Photographic Summary - Caveats

Door no. #2

Slide no. 4 of 13

Photographic Summary - Recommended Remedies

Gaps

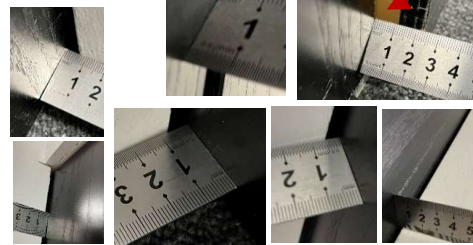
CAVEAT #7: The majority of gaps between the door and the frame exceed 4mm with a measurement of 7mm recorded at the top and 6mm in the middle of meeting edges; a reading of 22mm at the bottom edge of the main leaf and 13mm at the bottom edge of the side leaf was also noted.

REMEDY #7 In addition to **REMEDY #5 and #6**, because current FRA prepared by eg. Essex Fire Safety calls for fire and smoke doors (see page 30), BS 8214 section 13.2.3 recommends replacing seals which are compliant to BS476 pt 20/22 (fire) and 31.1 (smoke) or BSEN 1634-1 (fire) or 1634-3 (smoke) as a complete set. Seals should be as per the certificated test evidence for the door set and fitted by a competent person. Also fit a hardwood threshold to the floor and a drop threshold strip to the bottom edge of the door (accommodating flush bolt) eg. https://www.lorientuk.com/products/las8001-si_tom
